DEPARTMENT OF ENVIRONMENTAL QUALITY  
DIVISION OF RADIATION CONTROL

## MEMORANDUM

SUBJECT: International Uranium Corporation White Mesa Uranium Tailings Facility:  
Engineering Design and As-Built Reports; **Staff Findings, Conclusions, and  
Recommendations.**

Plot of IUC Tailings Cells 2 and 3  
Under drain Filter Gradation  
and Comparison with IUC Reported  
FML Bedding Layer Gradation

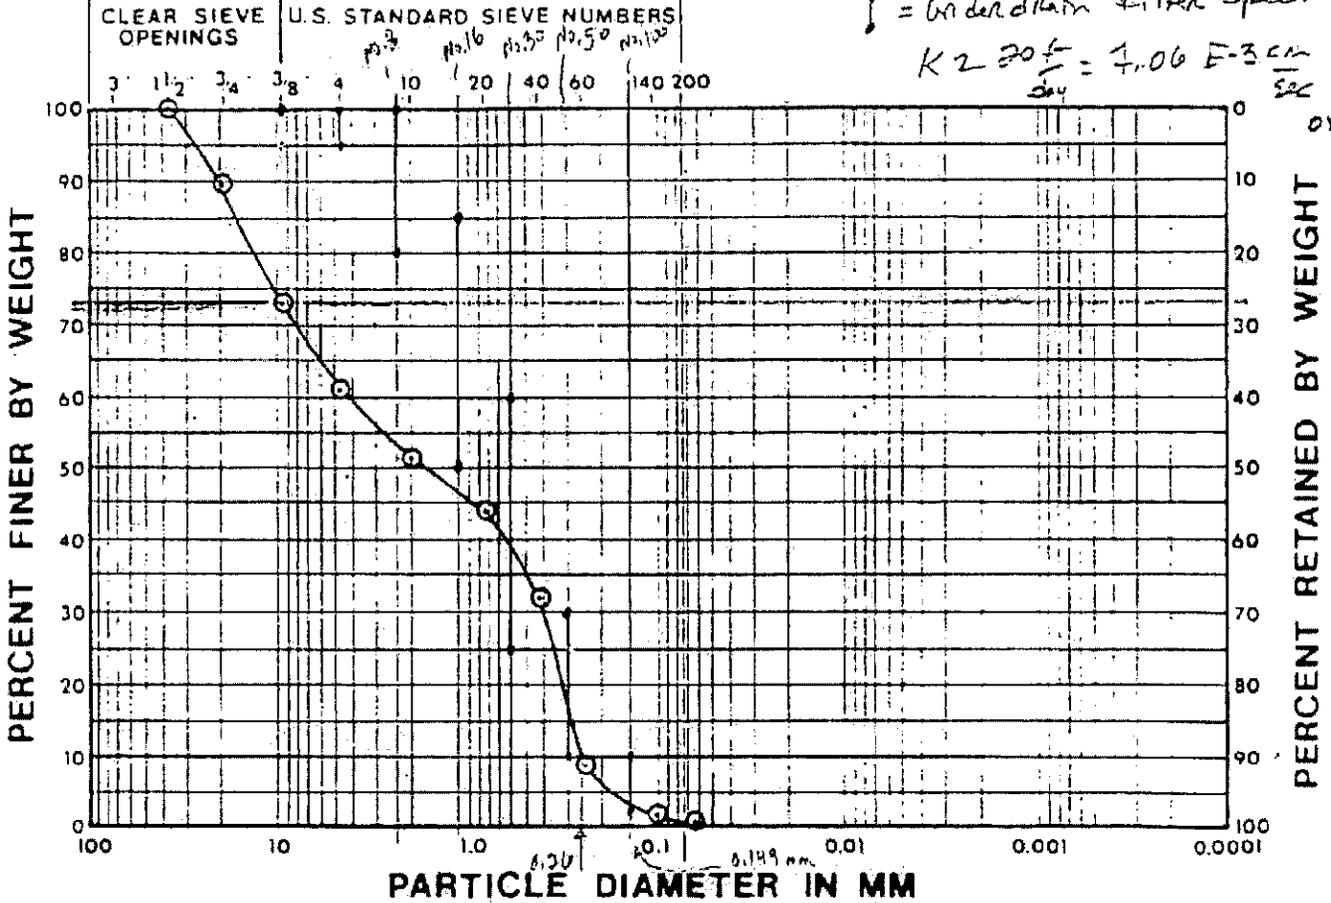
1. Permeability determined from IUC soil gradation data, as follows:
  - A. FML Bedding Layer - from IUC grain size analysis chart in 2/82 DCE As-Built Report, Figure 13; as determined from a U.S. Department of Transportation filter material permeability nomograph (Moulton, p.51). For details, see Attachment 3, below.

- C. Under drain Blanket - from IUC design specifications provided in the 6/79 DCE Design Report, Appendix B, p. 4-2. No as-built soil gradation data were provided in ; as determined from a U.S. Department of Transportation filter material permeability nomograph (Moulton, p.51). For details, see Attachment 3, below.
